**Economic Commission for Europe**
**Inland Transport Committee**
**World Forum for Harmonization of Vehicle Regulations**
**Working Party on Brakes and Running Gear**
**Eighty-fifth session**

**Report of the Working Party on Brakes and Running Gear  
 on its eighty-fifth session**
**Contents**

### Amendments to ECE/TRANS/WP.29/GRRF/2017/27

#### Proposal for a new 03 series of amendments to UN Regulation No. 79 (Steering equipment)

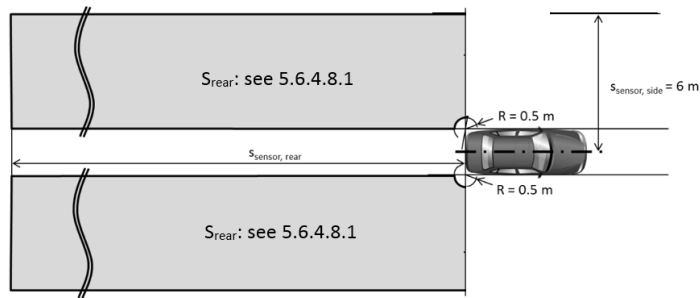
- 5.6.4.8.2. The vehicle system detection area on ground level shall be at minimum as shown in the figure below.
